**ADDENDUM  
NO. 3**

**September 30, 2025**

**VALE FACILITY ADDITION/RENOVATIONS AND  
MAINTENANCE/IT FACILITY PROJECTS**

**Addendum Three (AD.03)** to the drawings and specifications prepared by Gibraltar Design for **Valparaiso Vale Facility Addition/Renovations and Maintenance/It Facility and Related Work** for Valparaiso Community Schools, Valparaiso, Indiana.

GIBRALTAR DESIGN SHEET  
**A ED101**

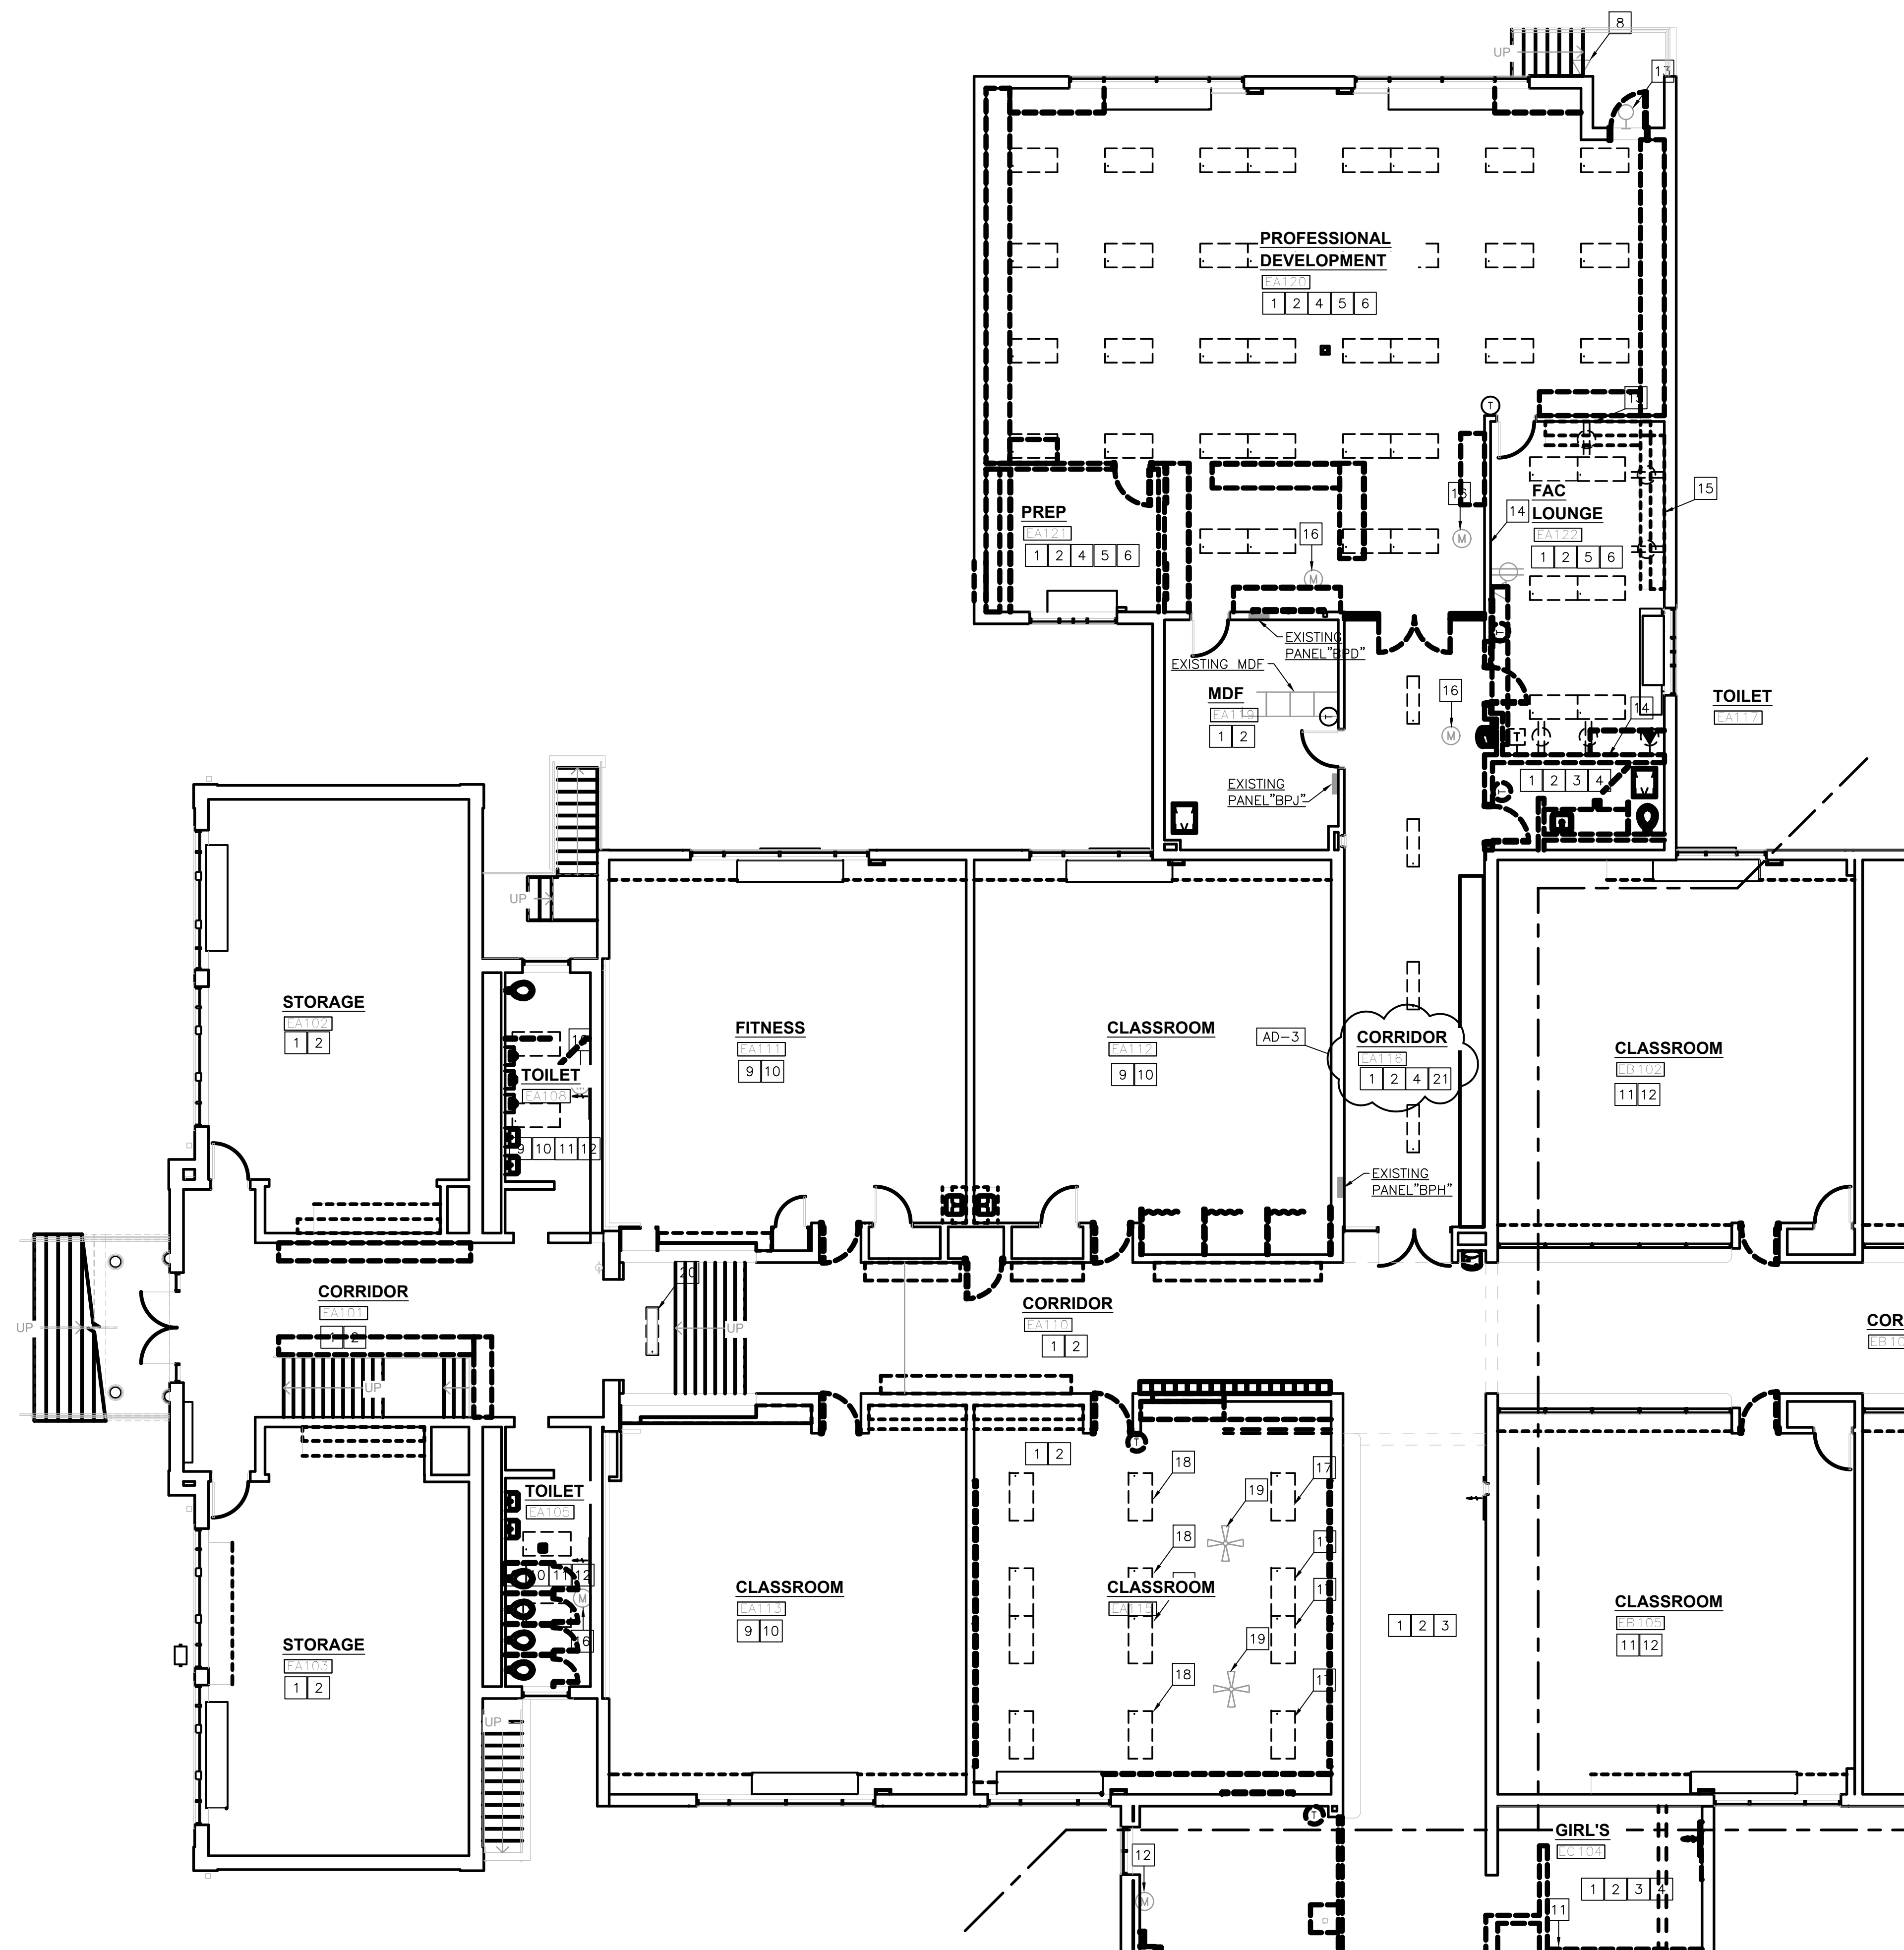
- A. Refer to revised, full-size drawing, included in this Addendum, for revisions.

GIBRALTAR DESIGN SHEET  
**A E-101**

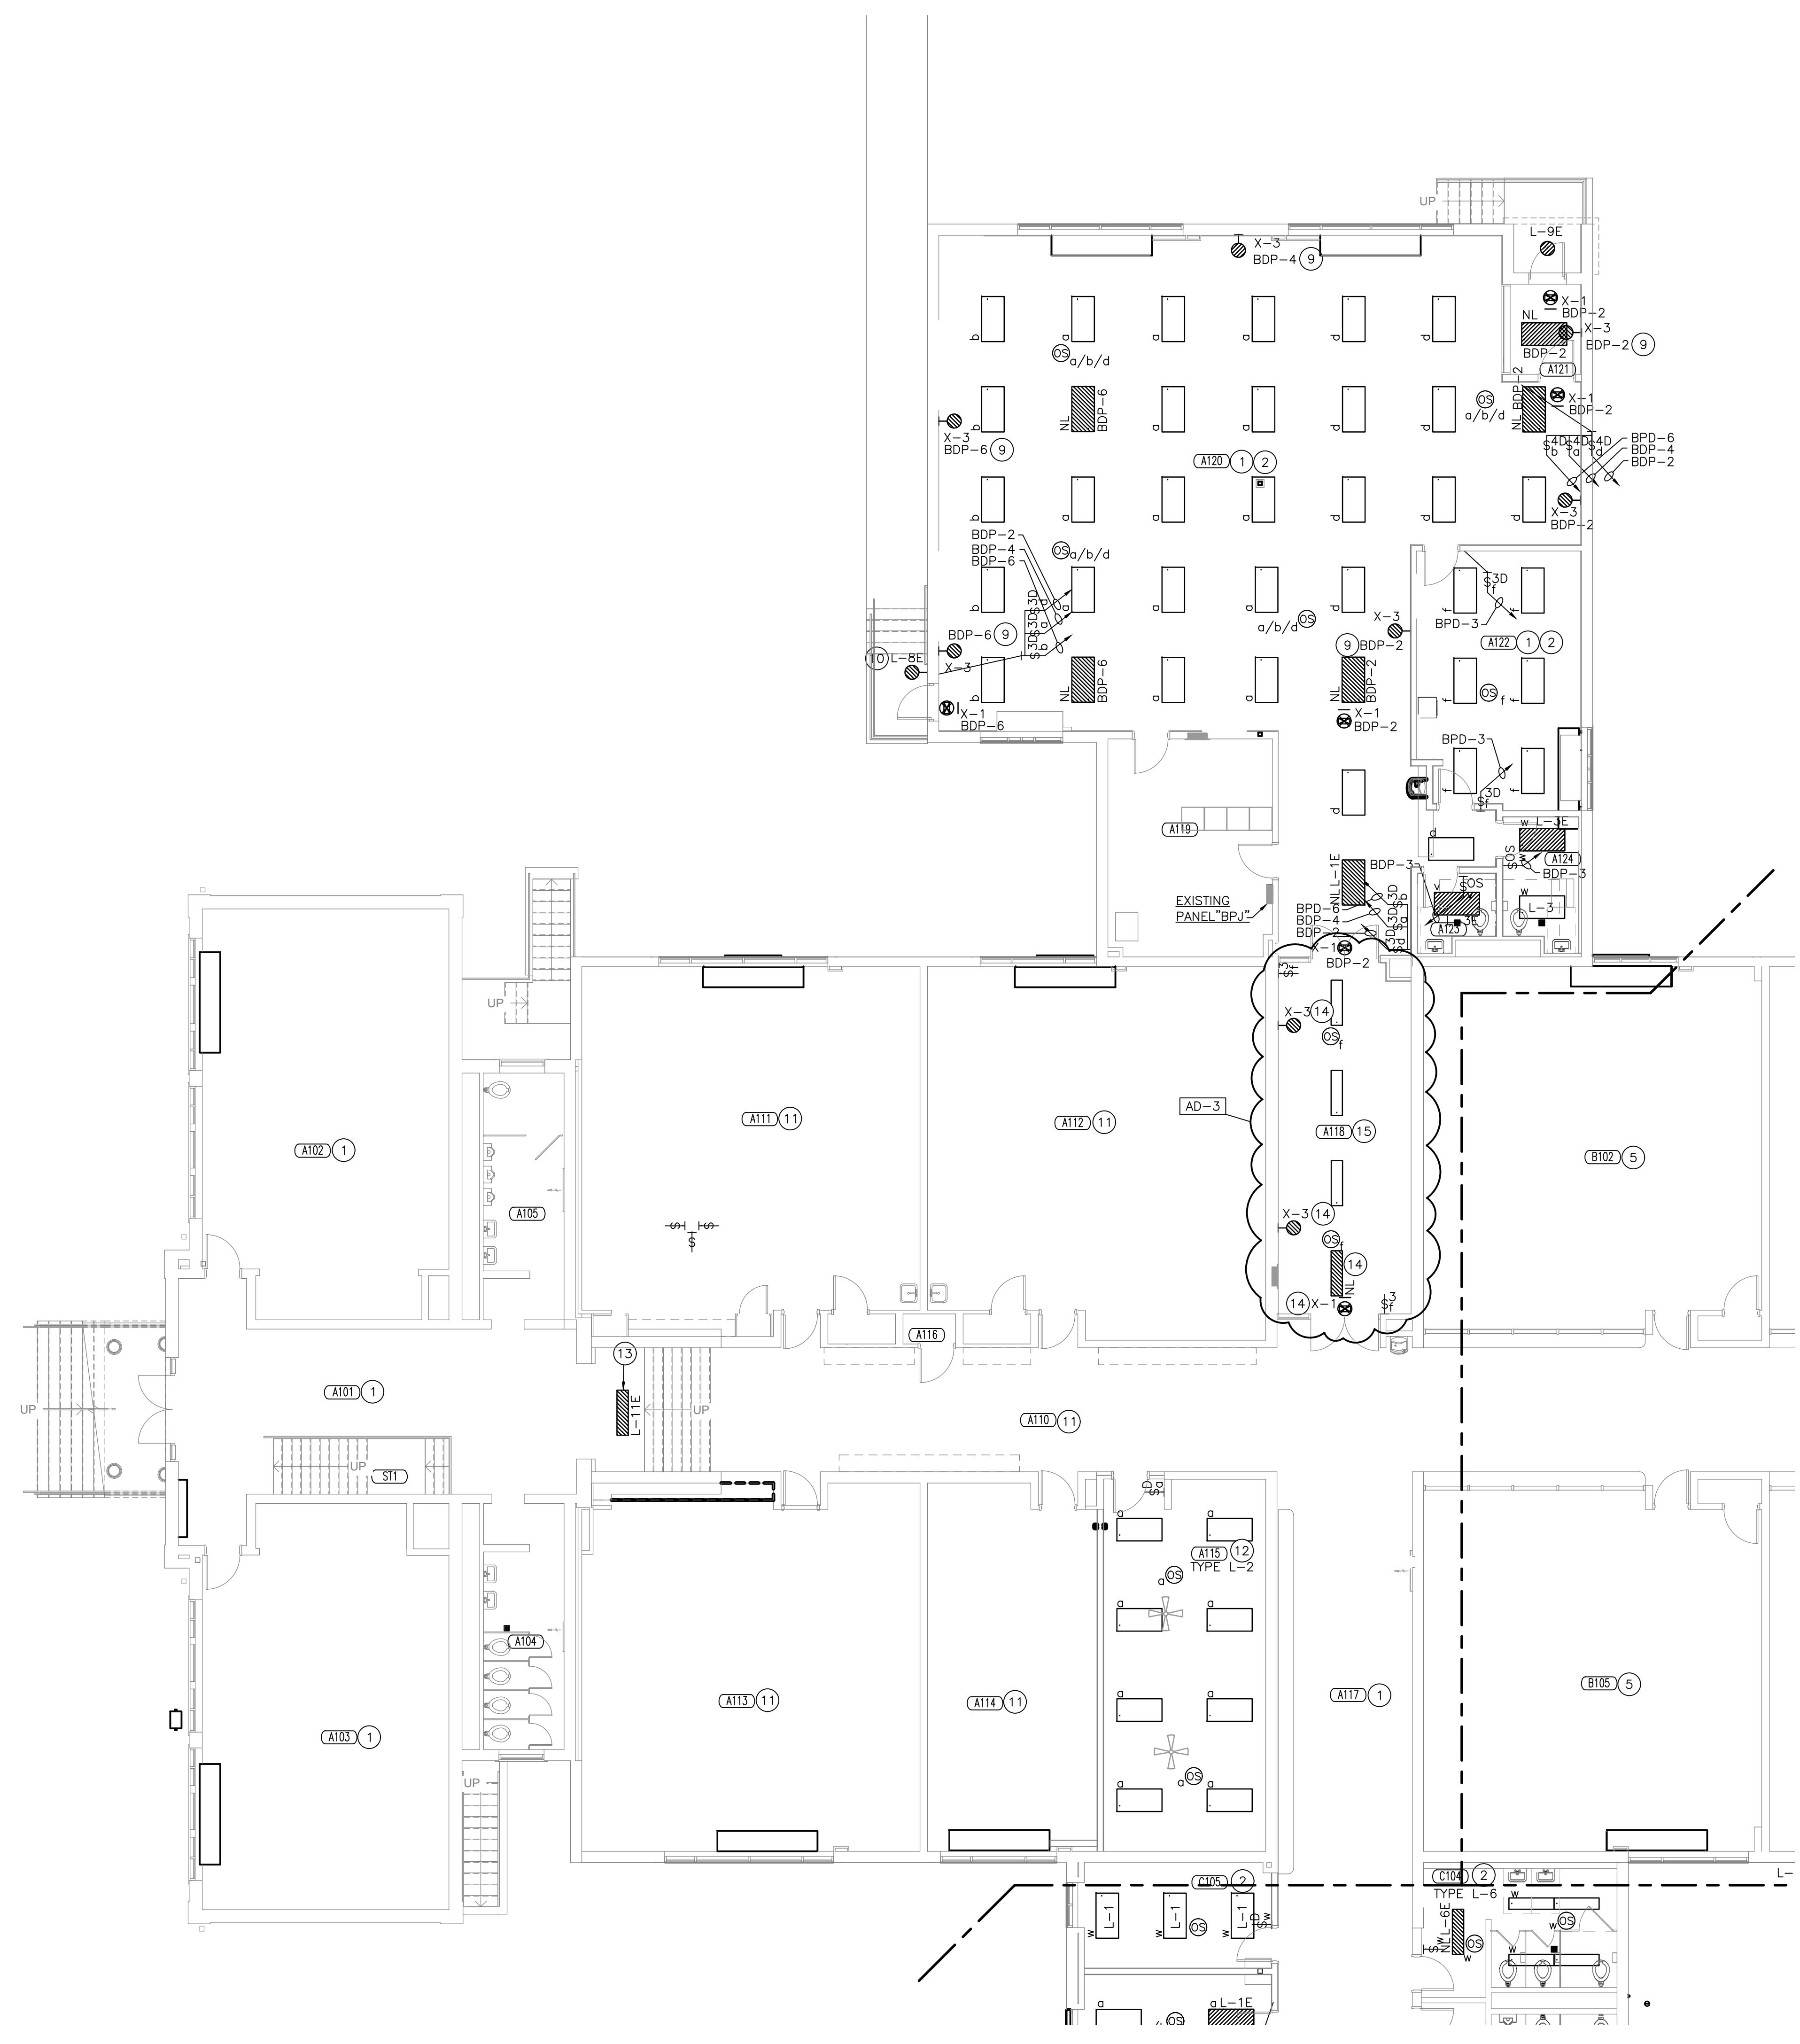
- A. Refer to revised, full-size drawing, included in this Addendum, for revisions.

© GIBRALTAR DESIGN SHEET  
**C E-203**

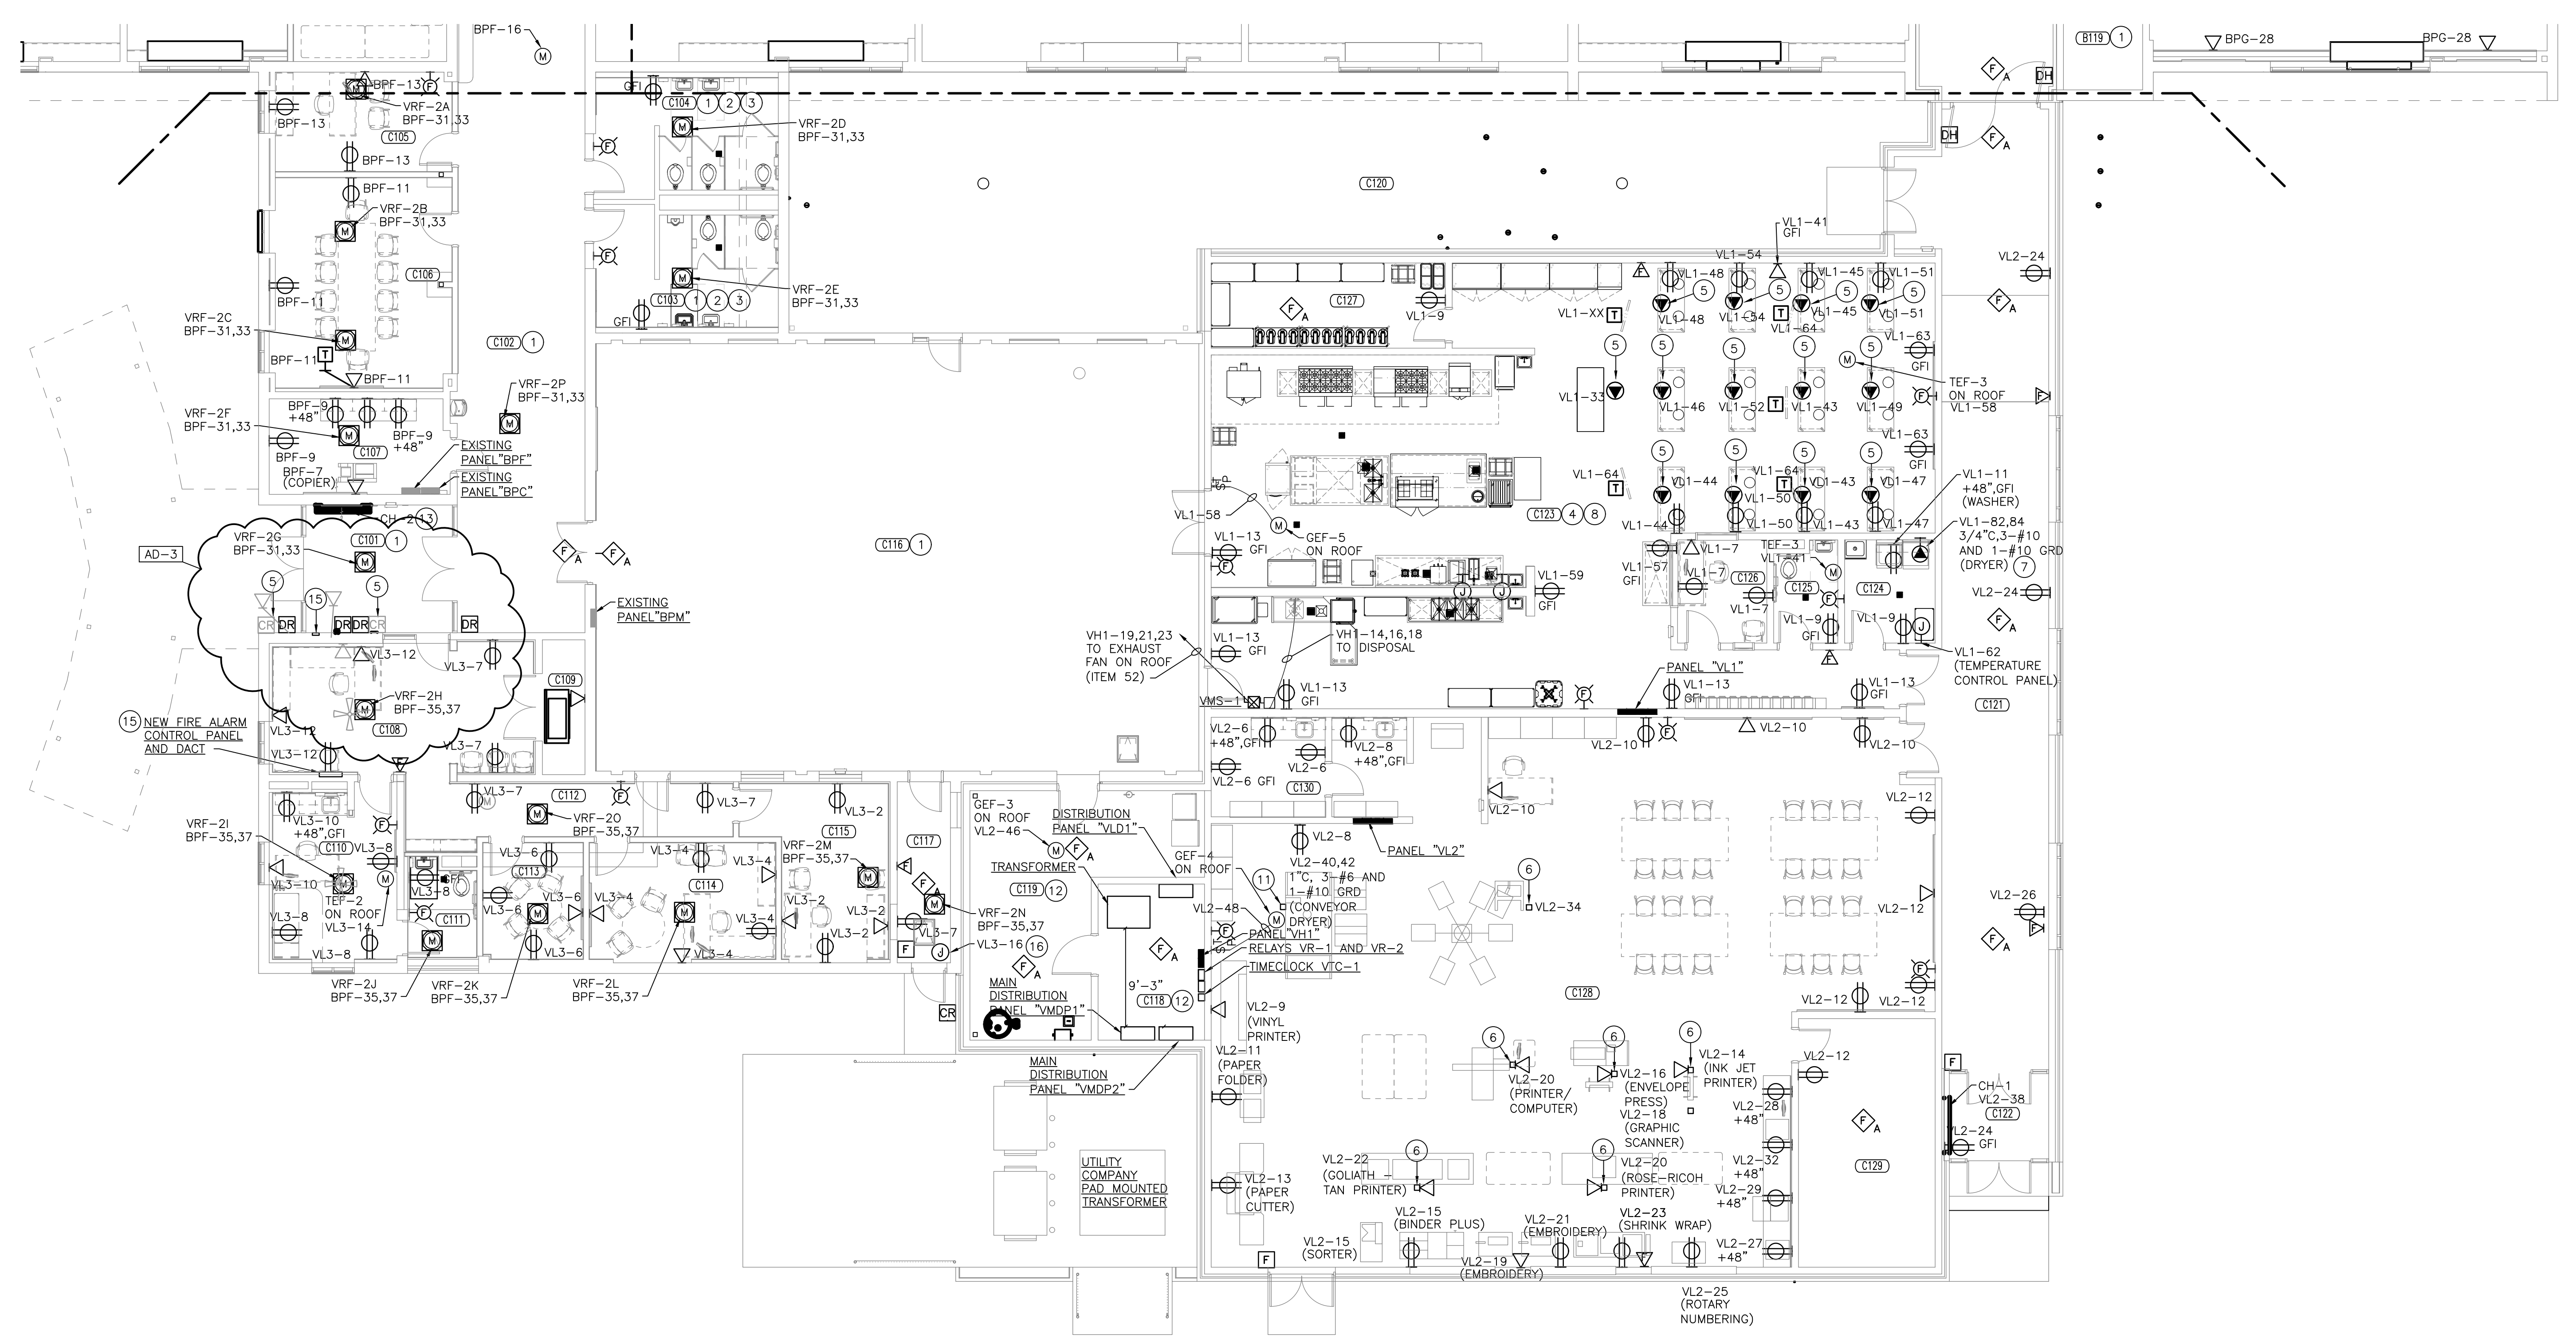
- A. In the existing renovated areas of the building where the new conduit cannot be installed concealed within the existing walls, the use of surface raceways is acceptable.
- B. The voice/data/video outlets shown on the electrical drawings are rough-ins only as noted on the details on the Electrical Detail Sheets. There may be more rough-in shown on the electrical drawings than actual wired voice/data/video outlets shown on the Technology Drawings. Provide the voice/data/video rough-ins shown on the electrical drawings and provide any additional Technology outlets/devices and all technology cabling for the voice/data/video outlets as shown and noted on the Technology Drawings.

- A. Refer to revised, full-size drawing, included in this Addendum, for revisions.
